# UNITED STATES PATENT AND TRADEMARK OFFICE

APPLICATION NO.	FILING DATE	FIRST NAMED INVENTOR	ATTORNEY DOCKET NO.	CONFIRMATION NO.
10/568,703	09/25/2008	Lars Bjorkholm	10400-000213/US	4723
36593 7590 12/21/2010 HARNESS, DICKEY & PIERCE, P.L.C. P.O. BOX 8910 RESTON, VA 20195				
EXAMINER				
HYLTON, ROBIN ANNETTE				
ART UNIT		PAPER NUMBER		
3781				
MAIL DATE		DELIVERY MODE		
12/21/2010		PAPER

# Office Action Summary

## DETAILED ACTION

FIG. 1

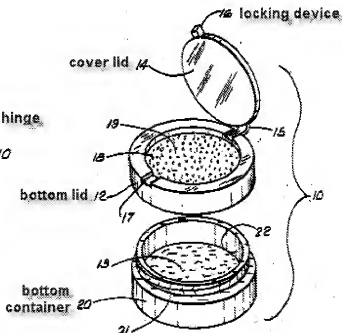
Vetter does not disclose the hinged joint comprises pins snapped into corresponding recesses in the bottom lid.

It would have been obvious to one having ordinary skill in the art at the time the invention was made to form the hinged joint of Vetter comprising pins and corresponding recesses since the examiner takes Official Notice of the equivalence of hinges with pins and corresponding recesses and tether hinges for their use in the closure art and the selection of any of these known equivalents to form a hinge joint between a lid and base would be within the level of ordinary skill in the art. Doing so provides a known alternative hinge joint structure for the lid.

Regarding claim 3, the cover lid is disclosed as completely sealing the opening and does not extend above the upper edge of the bottom lid. Wherein the cover lid is arguably not disclosed as being situated entirely under the upper edge of the bottom lid, it would have been obvious to one having ordinary skill in the art at the time the invention was made to form the lid such that the cover lid is entirely below the upper edge of the bottom lid to ensure sealing and avoid inadvertent opening of the cover lid.
